## Revision and Errata List

### AISC Seismic Design Manual, Second Printing

The following list represents corrections that have been made in the Third Printing of the Seismic Design Manual.

Replacement figure for Table 1-1.

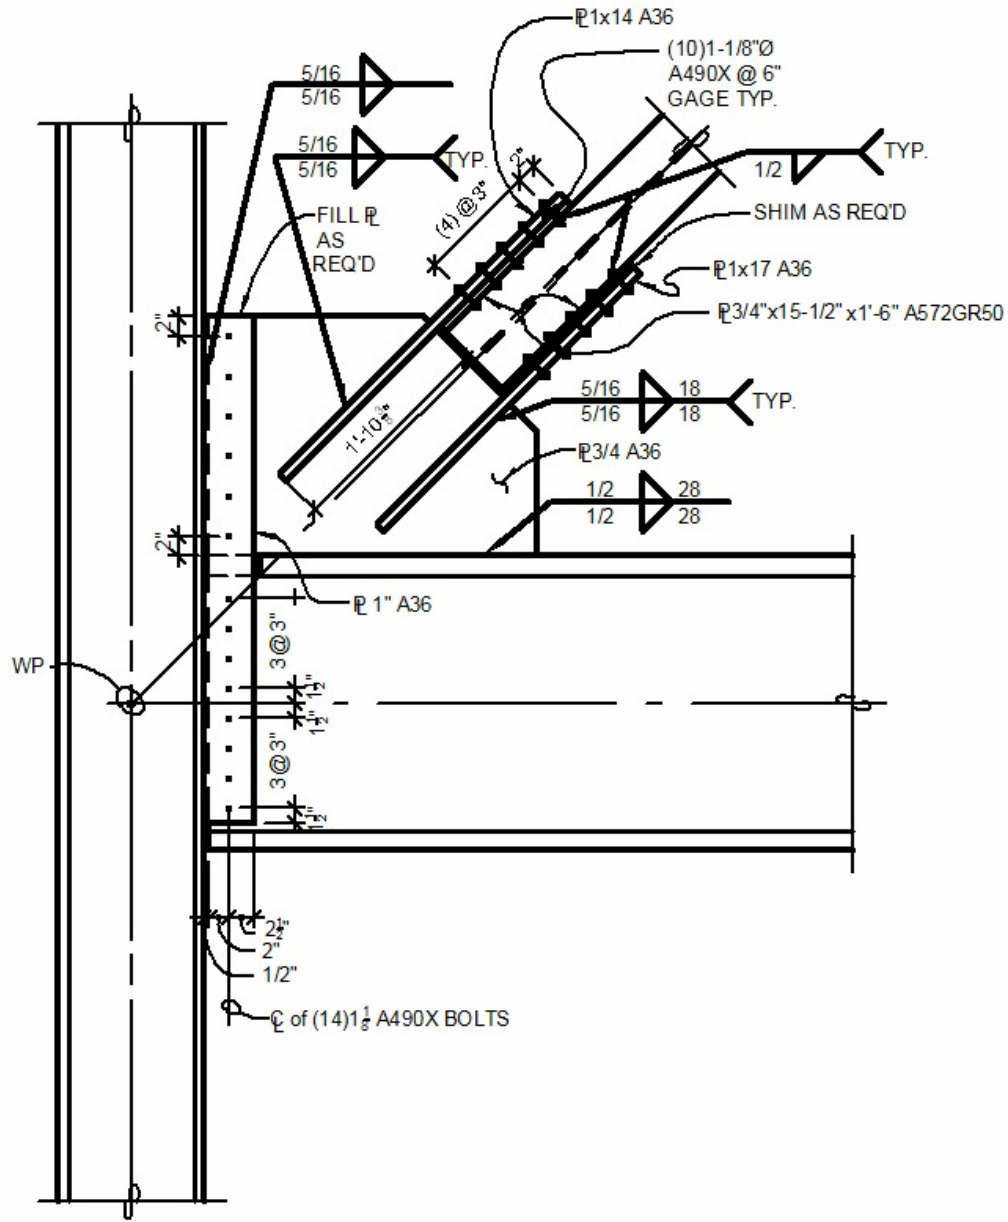
Page(s)	Item
1-18	Replace the Figure in Table 1-1 with the attached Figure.
3-26	In the first paragraph, the calculation for $\bar{\alpha}$ should be changed to, $\bar{\alpha} = \frac{1}{2} (12 \text{ in.} + \frac{1}{2} \text{ in.} - 5 \text{ in.} - \frac{1}{2} \text{ in.}) + 2 \frac{1}{2} \text{ in.} + \frac{1}{2} \text{ in.}$ $= 6.50 \text{ in.}$
3-27	In Figures 3-5a and 3-5b, the dimension " $e_c + 2\frac{1}{2}$ " should be replaced with " $e_c$ ".
3-48	In the fourth line, replace " $= 332 \text{ kips}$ " with " $= 322 \text{ kips}$ ".
3-106	Replace Figure 3-24 with the attached Figure 3-24.
